FSN MA-FCO 71200185

URGENT - Field Safety Notice Patient support

Hardware update of Patient Support (12NC 989001087431)

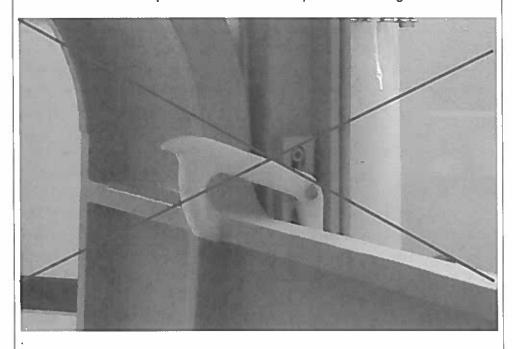
The customer / user should always check the right position of the hook and that the hook is locked according to IfU. (Press hook down until it is locked) Make sure that the hook is in position as shown in the picture with the green arrow

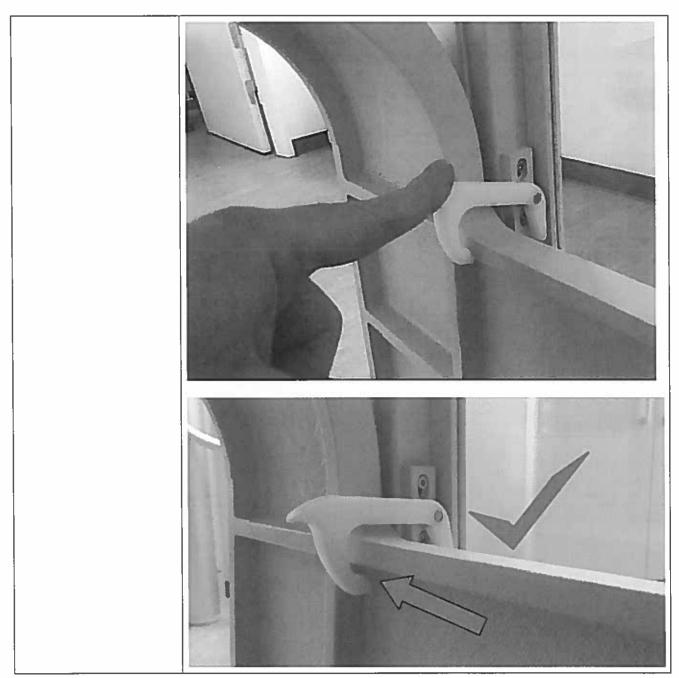
ACTIONS PLANNED BY PHILIPS	Philips plans to redesign the: sturdier replacement hinges for floor plate install modified hook for floor plate (adapted to new hinges) brake cylinder below floor plate to minimize kinetic energy
	A Philips Service Engineer will contact you as soon as the Field Action Kit is ready to be implemented. Should you need to communicate with Philips in regards to this program, please reference FCO-71200185.
FURTHER INFORMATION AND SUPPORT	If you need any further information or support concerning this issue, please contact your local Philips representative.
